Re: 09-AFC-6 Blythe Solar Power Plant Project

Enclosed are an original and one copy of CALIFORNIA UNIONS FOR RELIABLE ENERGY DATA REQUESTS SET ONE. Please process the document and provide us with a conformed copy in the envelope provided.

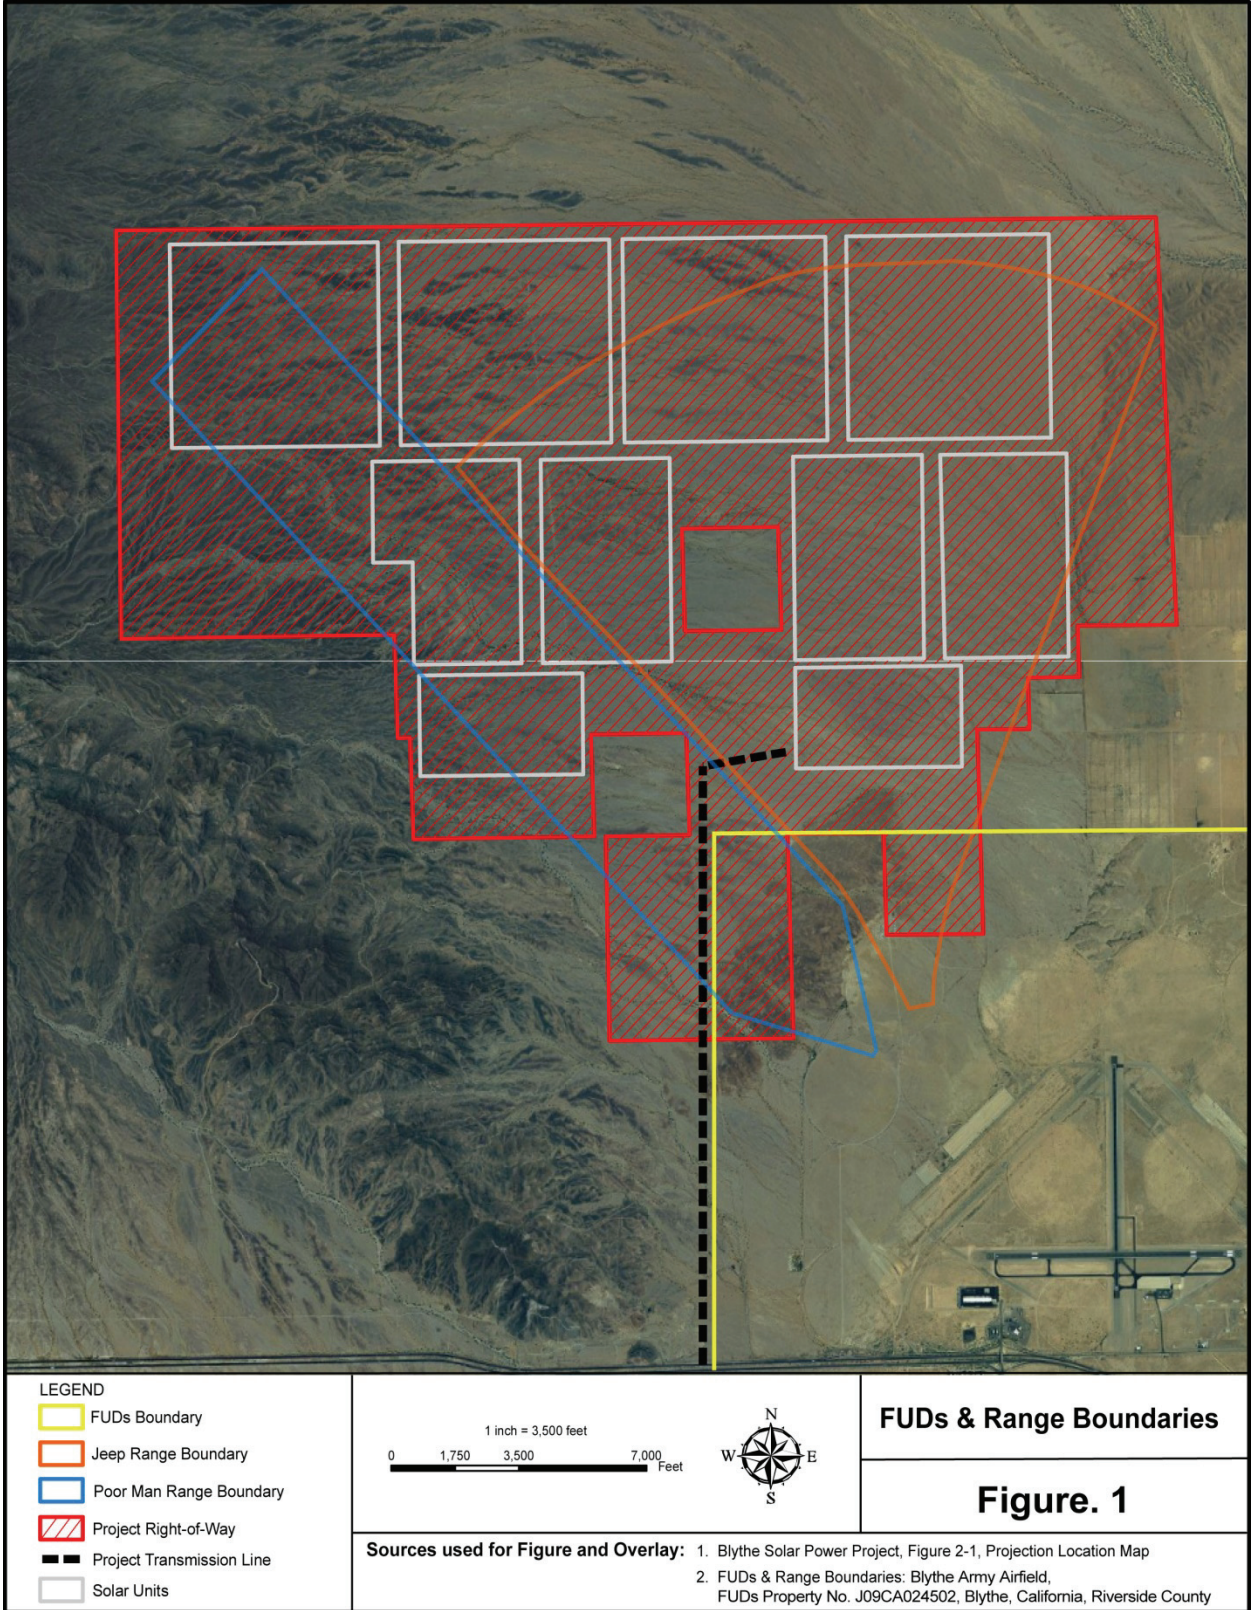
The Blythe Army Airfield is a formerly used defense site (“FUDS”) which extends into the Project action area as shown in the below Figure.<sup>215</sup>
